TECHNICAL BULLETIN

No: LA-413-001
Issue: 1
Date: 27 Sep 2005

Parking Distance System Intermittent Operation

Land Rover LR3 (LA)

Figure 1

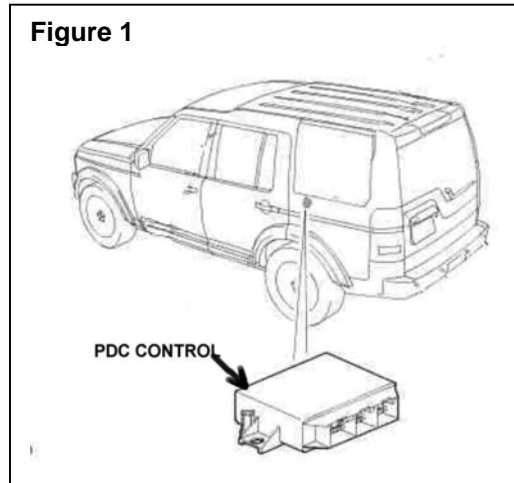
2. Refer to LR3 Workshop Manual Section 501-05 and remove the C-pillar lower trim panel.
3. Remove the parking aid module as follows:
(Figures 1 and 2)
 - Remove the two retaining nuts.
 - Disconnect the three electrical connectors.
4. Replace the parking aid module with a new unit as follows:
 - Connect and secure the electrical connectors to the new unit
 - Tighten the retaining nuts to **5Nm (4 lbf-ft)**.
5. Refer to LR3 Workshop Manual Section 414-00 and install the C-pillar lower trim panel.
6. Refer to LR3 Workshop Manual Section 501-05 and connect the battery ground cable.
